**Lower Manhattan Development Corporation  
World Trade Center Memorial and Cultural Program  
General Project Plan  
Proposed Amendments December 16, 2004**

PROPOSED SITE PLAN AS OF DECEMBER, 2004  
ATTACHMENT 1

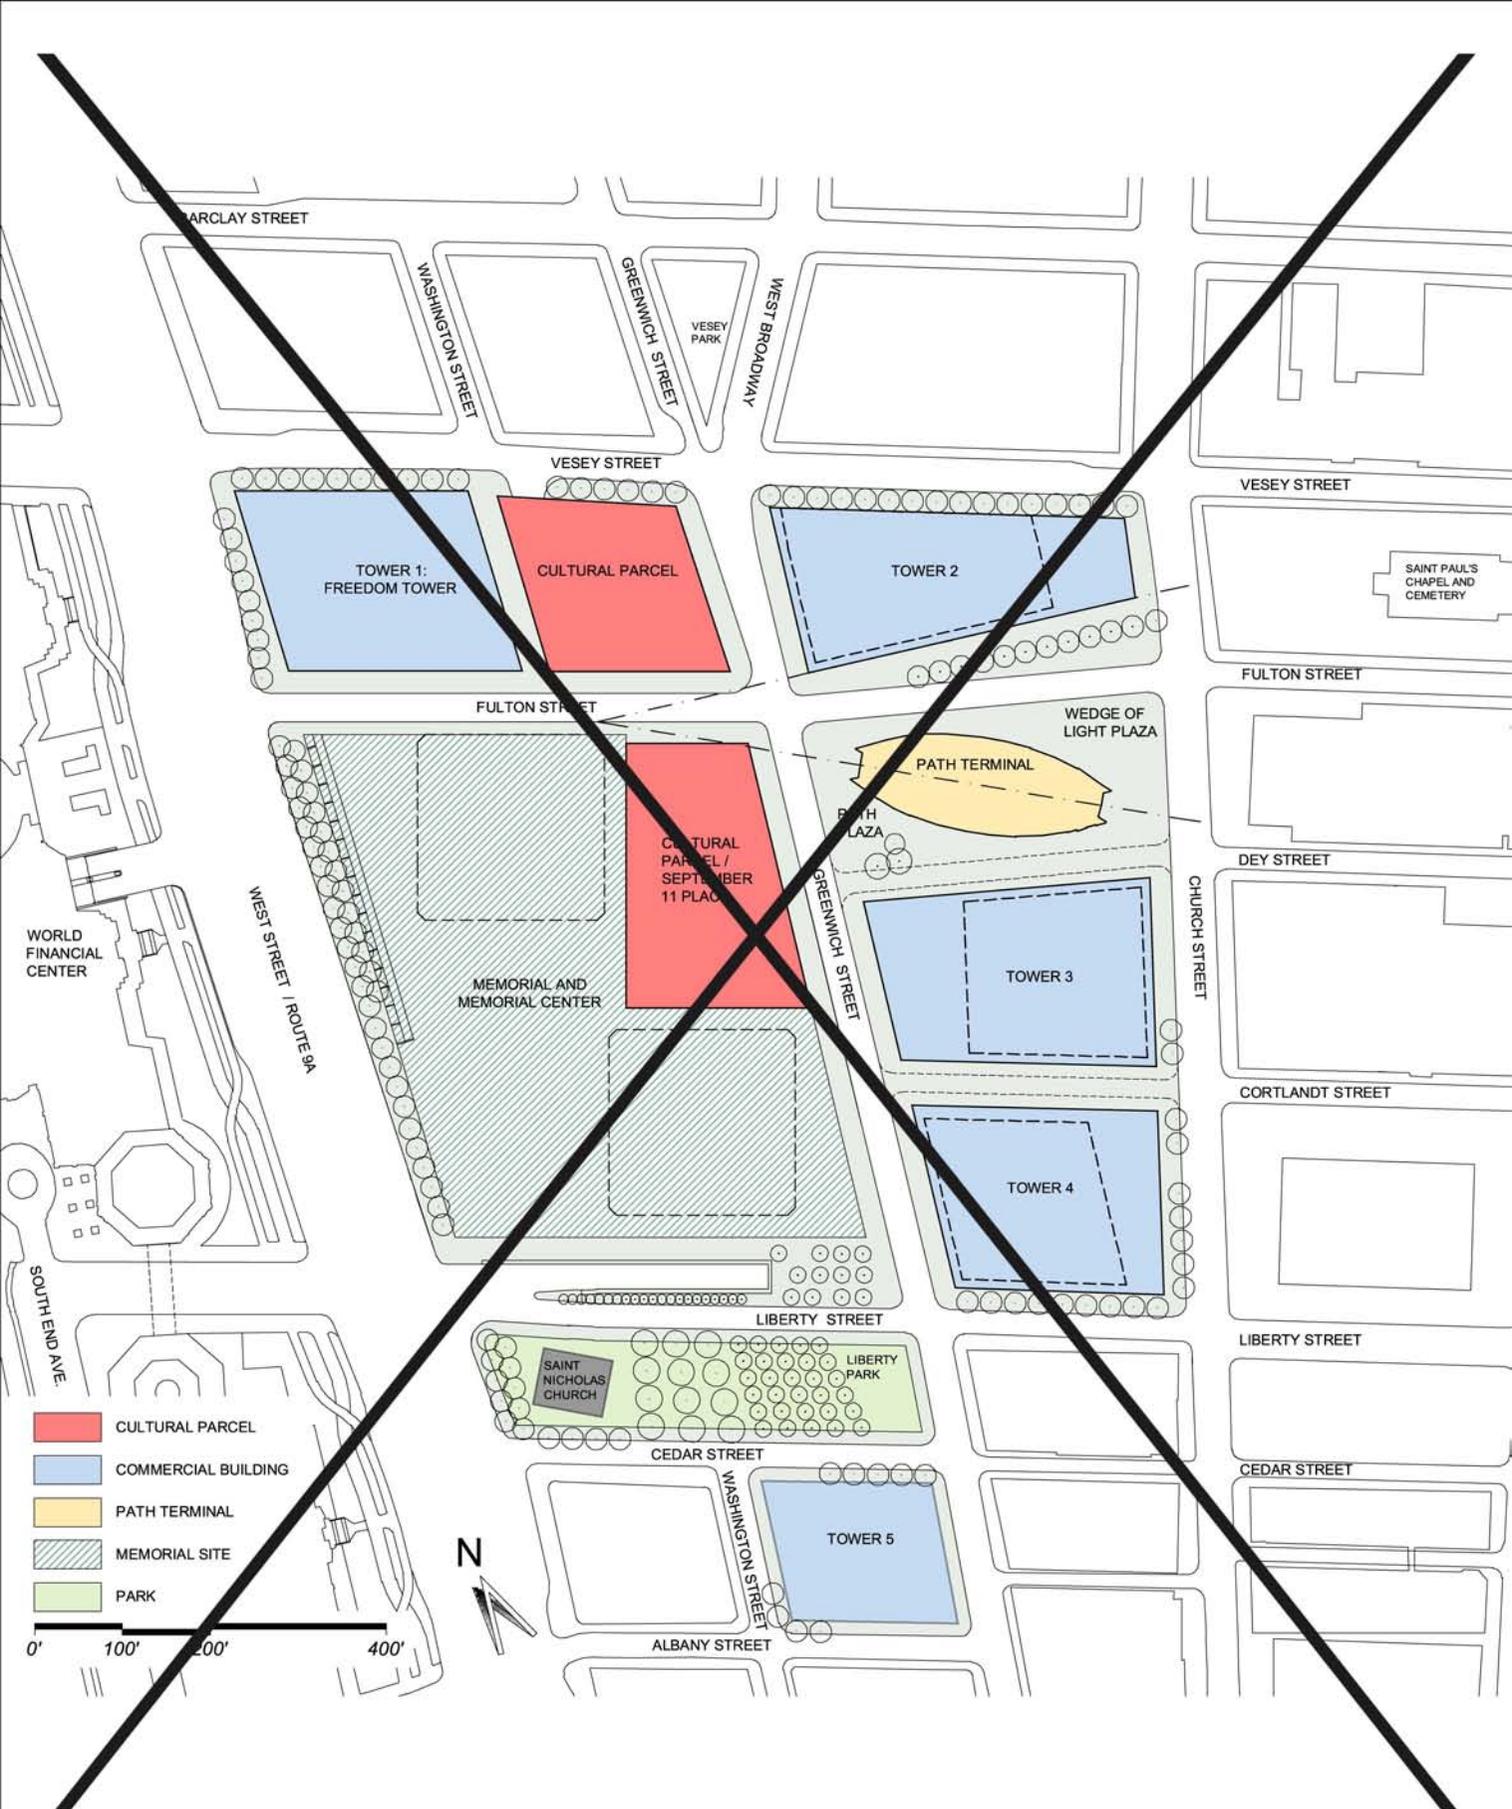
The Site is located in Lower Manhattan on two sites, *as shown on Attachment 1*: (i) the WTC Site, bounded by West, Vesey, Church, and Liberty Streets; and (ii) the adjacent ~~two city blocks south~~ ***Southern Site immediately to the south of the WTC site Site comprising (a) two city blocks***, one bounded by Liberty, Washington, Albany and Greenwich Streets, and the other bounded by Liberty, West, Cedar and Washington Streets, ~~and~~ ***(b) subsurface portions of two streets: Liberty Street between those blocks and the WTC Site and from the eastern side of West Street to the western side of Greenwich Street, (c) Washington Street between from the northern side of Cedar Street and to the southern side of Liberty Streets, and (d) subsurface portions of Cedar Street from the eastern side of West Street to the eastern side of Washington Street (collectively, the "Southern Site")***. The Southern Site includes those properties commonly known as 130 Liberty Street, 140 Liberty Street and 155 Cedar Street. ~~The boundaries of the Site are shown on Attachment 1. (World Trade Center Memorial and Redevelopment Plan, Proposed Site Plan as of June 2004).~~

***As contemplated by the Plan and as shown on Attachment 1, Washington Street between Cedar and Liberty Streets will be closed and incorporated into Liberty Park. In addition, subsurface portions of Cedar and Liberty Streets will be incorporated into the below-grade infrastructure at the Site. To the extent the Plan eliminates those portions of Cedar, Liberty, and Washington Streets, which are mapped streets, it is inconsistent with the City***
